BRIDGE 25
PIER #1
SCALE: 1/8" = 1'-0"
XBR25-5

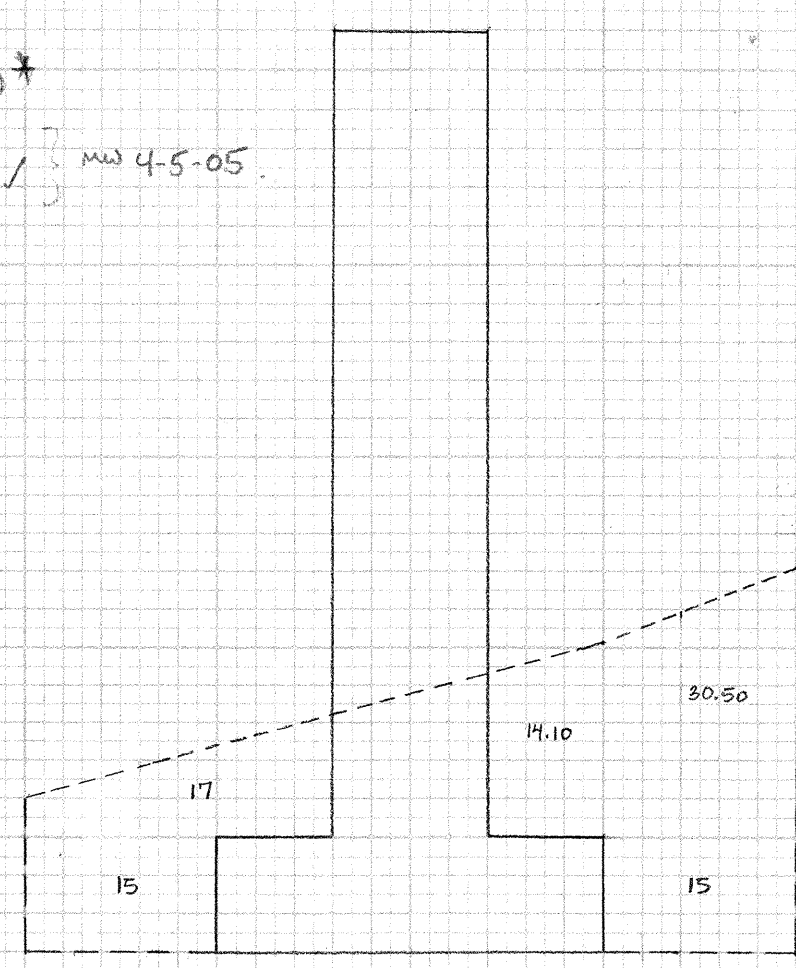
9/22-03 JDC
208.30-175.87+104.30-112.40 SQ. FT. $\checkmark$ V010
613.13: 34.40+15+15+15= 112.40 SQ. FT. $\checkmark$ MW 4-5-04

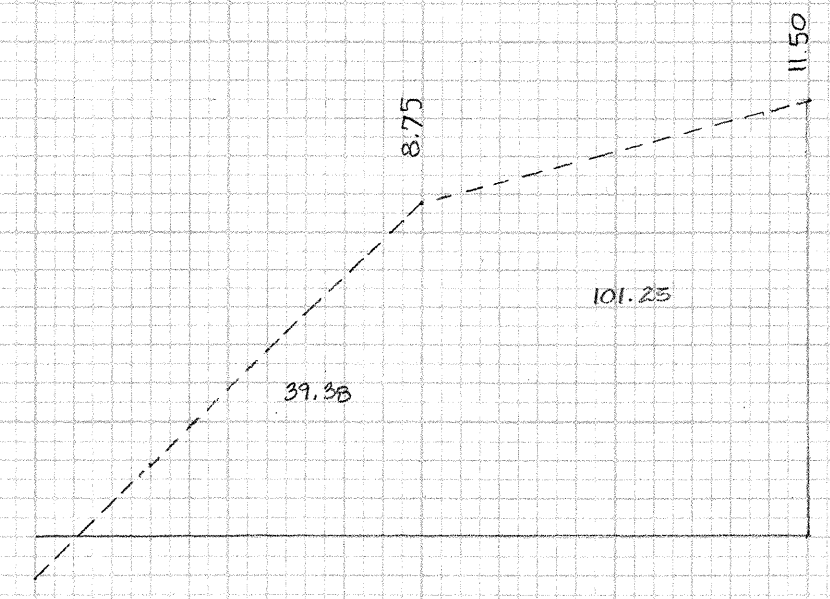
9/22-03 JDC
208.30-175.87+104.30-112.40 SQ. FT. $\checkmark$ V010
613.13: 17+15+14.10+30.30+15= 91.60 SQ. FT. $\checkmark$ MW 4-5-05

* ITEM 208.30 CALCULATIONS
NOT BASED ON THESE SECTIONS
SEE CALCULATION SHEETS IN
BRIDGE COMPUTATION BINDER, BR25
208.30-25-PI-1 ~ PI-2
208.30-25-PI-1 ~ PI-2

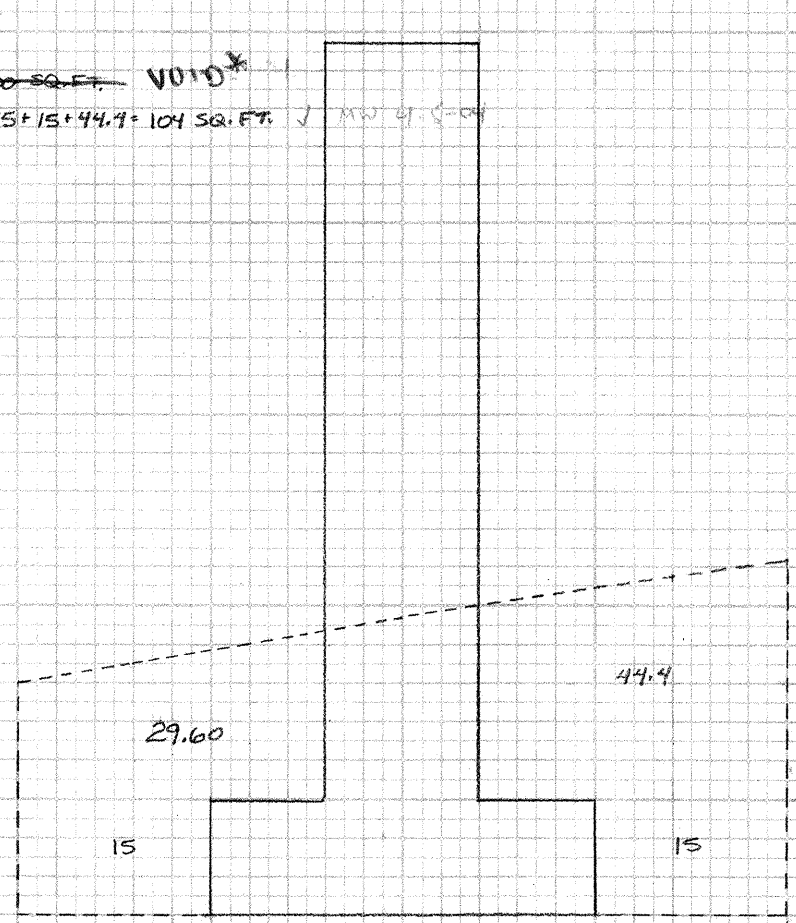
9/22-03 JDC
208.30-175.87+104.30-112.40 SQ. FT. $\checkmark$ V010
613.13: 29.60+15+15+14.4+104 SQ. FT. $\checkmark$ MW 4-5-04

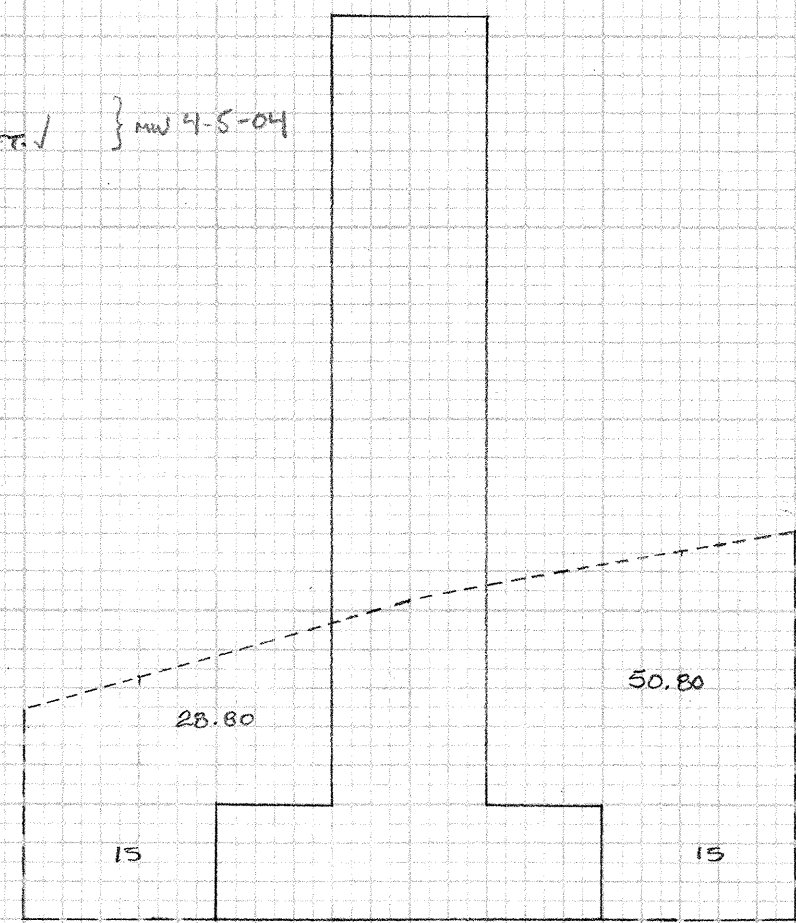
9/22-03 JDC
208.30-175.87+104.30-112.40 SQ. FT. $\checkmark$ V010
613.13: 28.80+15+15+50.80= 109.60 SQ. FT. $\checkmark$ MW 4-5-04

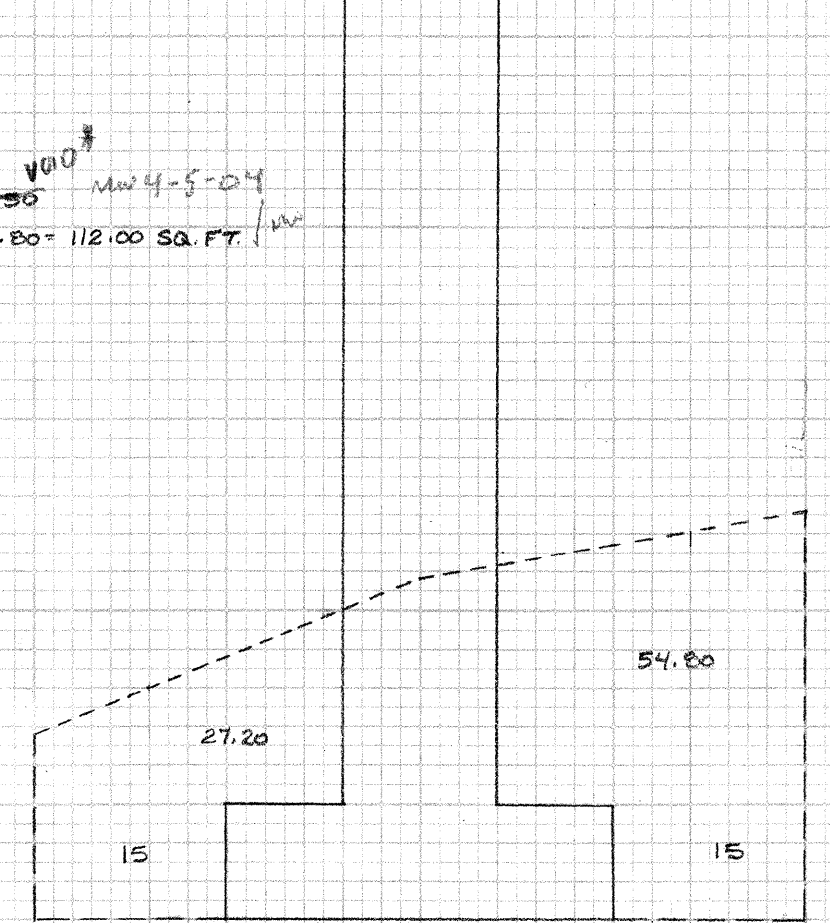
9/22-03 JDC
208.30-175.87+104.30-112.40 SQ. FT. $\checkmark$ V010
613.13: 27.20+15+15+54.80= 112.00 SQ. FT. $\checkmark$ MW 4-5-04

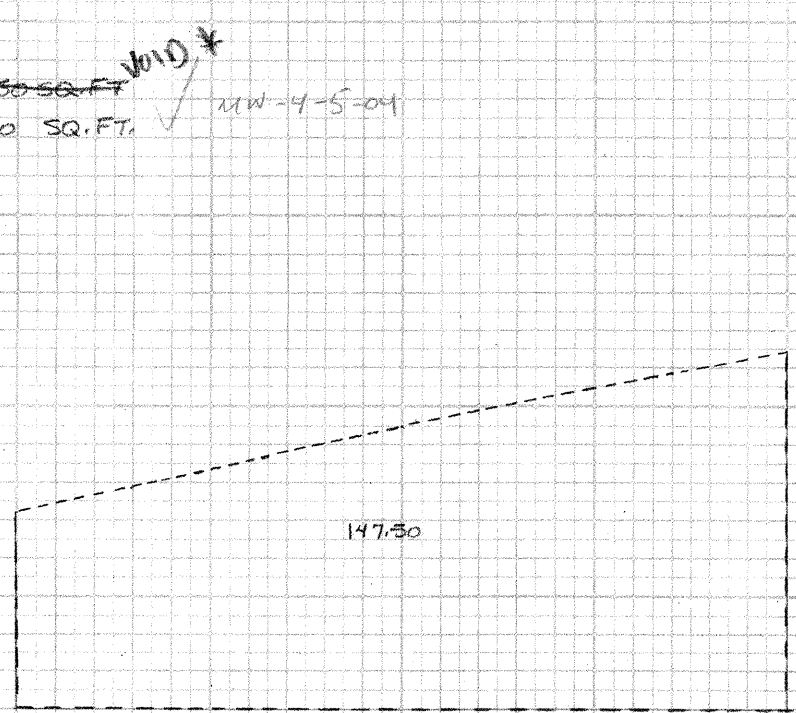
9/22-03 JDC
208.30-175.87+104.30-112.40 SQ. FT. $\checkmark$ V010
613.13: 17.50 SQ. FT. $\checkmark$ MW 4-5-04

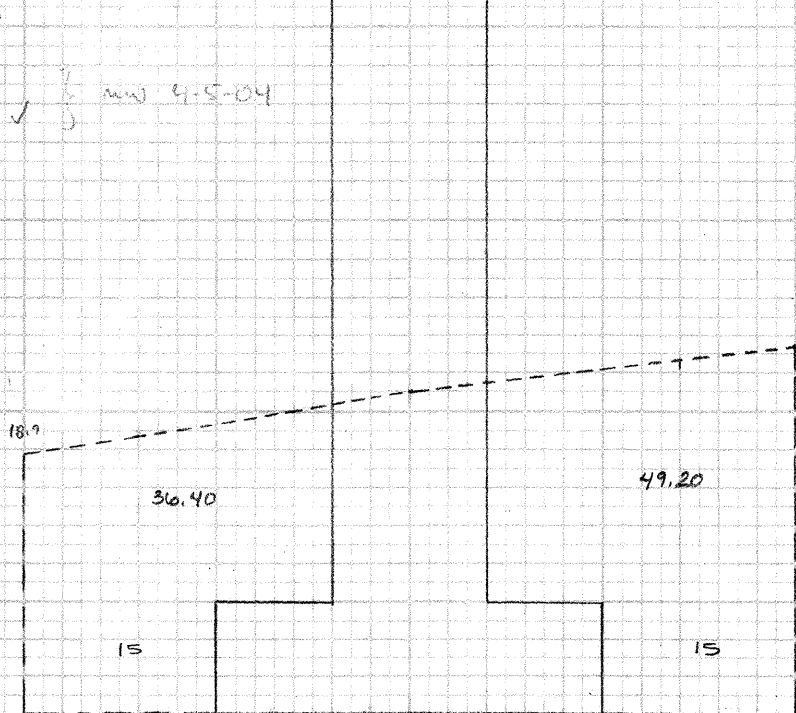
9/22-03 JDC
208.30-175.87+104.30-112.40 SQ. FT. $\checkmark$ V010
613.13: 36.40+15+15+49.20= 115.60 SQ. FT. $\checkmark$ MW 4-5-04

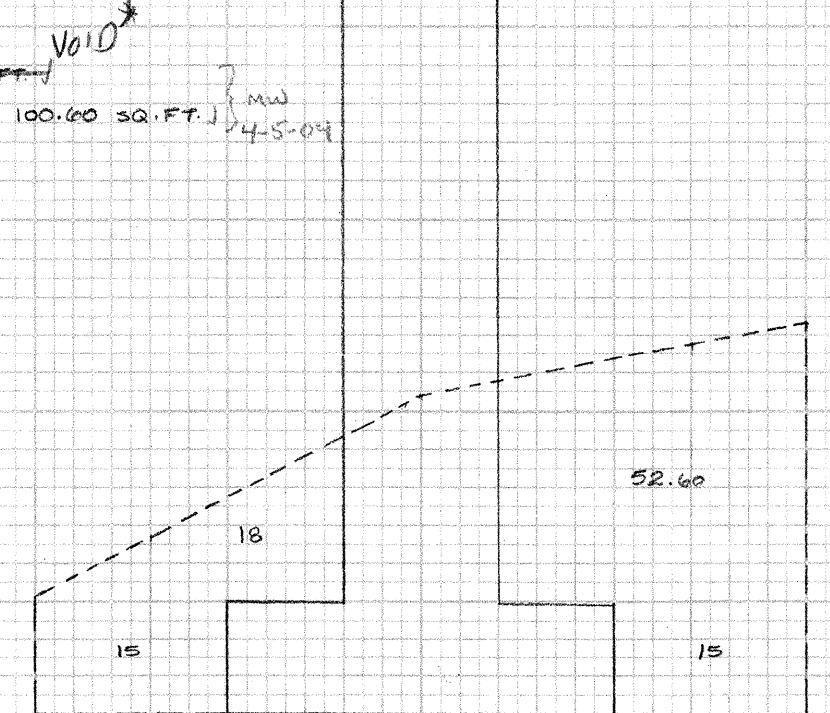
9/22-03 JDC
208.30-175.87+104.30-112.40 SQ. FT. $\checkmark$ V010
613.13: 18+15+15+52.60= 100.60 SQ. FT. $\checkmark$ MW 4-5-04
